Design Compliance Report

Development Application Design Review

Proposed Mixed-Use Building at 4 Delmar and 812 Pittwater Road, Dee Why

Report Number & Revision:	MSA2246_BCA_DA_01
Prepared For:	Landmark Group C/- Willow Frank
Date of Issue:	25.11.2021

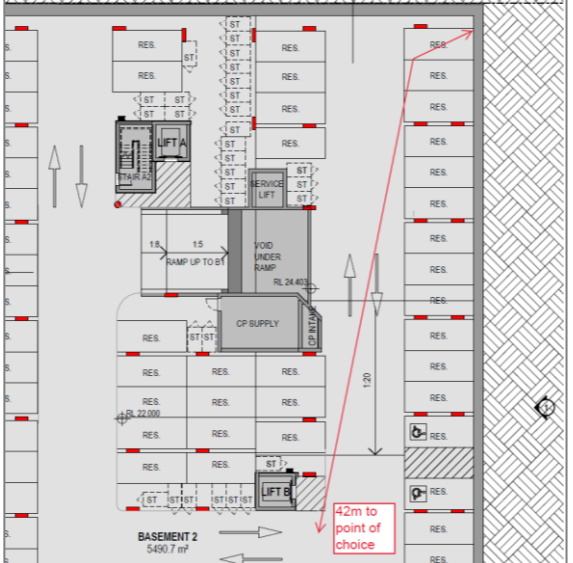
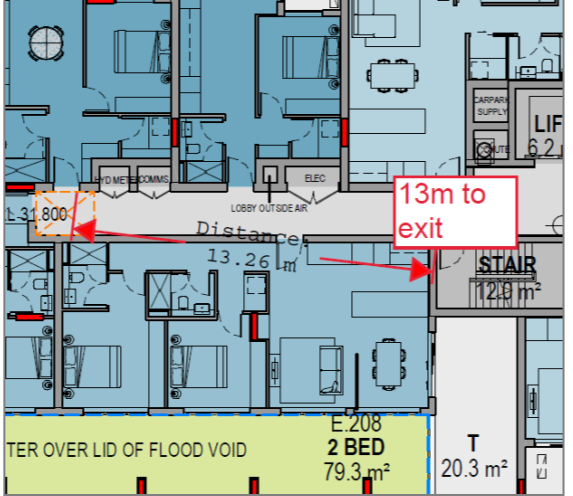
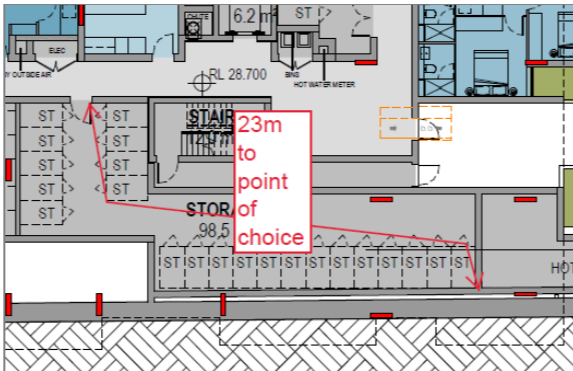
BCA Cl.	BCA Requirement	Compliance Comment	Status
	Provides requirements for open space and vehicular Access for large isolated buildings.		
C2.5	Class 9a & 9c Buildings Class 9a and 9c buildings are subject to further requirements in terms of smoke and fire compartmentation. Note BCA NSW C2.5 contains variations to this clause (Applicable in NSW)	The building is not a Class 9a or 9c building.	NA
C2.6	Vertical Separation of Openings in External Walls In sprinklered buildings required to be of Type A construction, openings in external walls are required to be protected with vertical spandrels or horizontal slabs to prevent fire from spreading from a storey below. Vertical separation must be in the form of: <ul style="list-style-type: none"> 'Vertical spandrels' which must be non-combustible, have a FRL of at least 60/60/60, and a height of at least 900mm. At least 600mm must be above the surface of the intervening floor; OR Horizontal Slab separation (e.g. balcony) – which must have a FRL of not less than 60/60/60 and extend outwards of the opening not less than 1100mm and horizontally not less than 450mm from the side of the opening. 	As the building (containing class 2 parts) has a rise in storeys of more than 3 (and as the carpark accommodates >40 vehicles) a sprinkler system is required under BCA E1.5. throughout. BCA E1.5 requires a AS2118.1 system to be provided in the carpark portion, but allows a variety of sprinkler systems to be installed in the residential portion with additional concessions granted depending on the type of system selected. <u>Note - Where a AS2118.1 system is installed throughout, the requirements of this clause are non-applicable.</u> As shown in the example below, there appear to be areas requiring vertical separation. 	Can Readily Comply

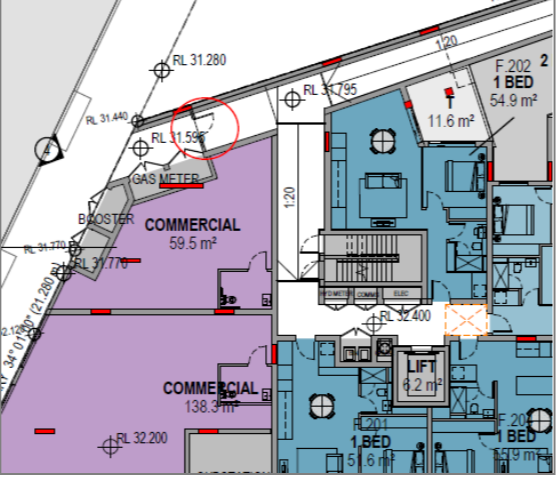
BCA Cl.	BCA Requirement	Compliance Comment	Status
		 <p>Residential levels</p> <ul style="list-style-type: none"> • SOU entry doors >12m from an exit or point of choice  <p>Storage Areas (Ground floor)</p> <ul style="list-style-type: none"> • Points on the floor more than 20m from an exit or point of choice 	
D1.5	<p>Distance Between Alternative Exits</p> <ul style="list-style-type: none"> • BCA requires that where exits are provided as 'alternative' should be distributed as uniformly as possible around the storey. 	<p>Basement Levels – alternative exits are more than 60m apart are proposed to be addressed via performance solution. Note plan extracts show examples only and are not intended to identify all travel distance issues.</p>	Performance Solution Required
